STAFF REPORT: MAY 11, 2022 MEETING

APPLICATION NUMBER: #22-7819

ADDRESS: 259 W. GRAND BOULEVARD

SCOPE OF WORK: REPLACE EXISTING VINYL AND WOOD WINDOWS WITH NEW WOOD WINDOWS

259 W. Grand, current appearance

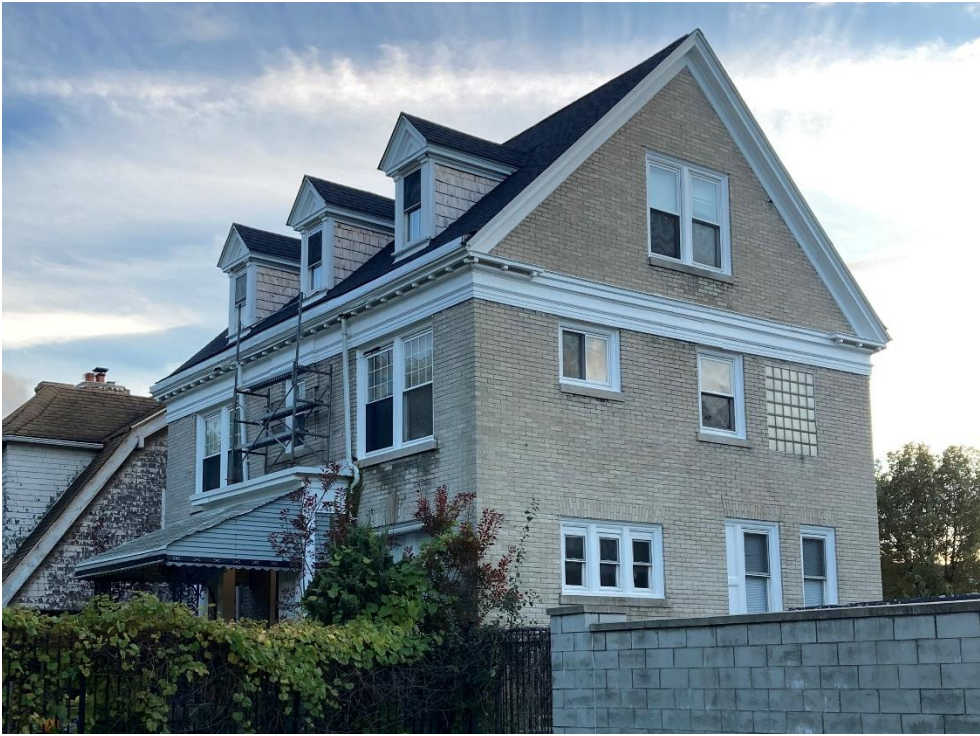
- It is staff's opinion that the current wood picture/fixed windows at the front elevation, first story, are not compatible with the building's historic appearance. Therefore, the replacement of the existing, non-compatible fixed wood windows at the front elevation with new fixed wood windows do not meet the Standards. Should these windows be replaced, staff recommends that the new windows match the configuration and operation of the windows at the second story, front elevation. Specifically, a set of paired 1/1, double-hung aluminum clad, wood windows with mullion should be installed within each opening

- Should the fixed wood windows at the front elevation, first story, be replaced, the new windows shall match the condition/configuration of the windows at the front elevation second story. Specifically, a set of paired 1/1, double-hung aluminum clad, wood windows with wood mullion and trim/brickmould shall be installed in each opening. HDC staff shall be afforded the opportunity to review and approve the final proposal for the front elevation, first story replacement windows.
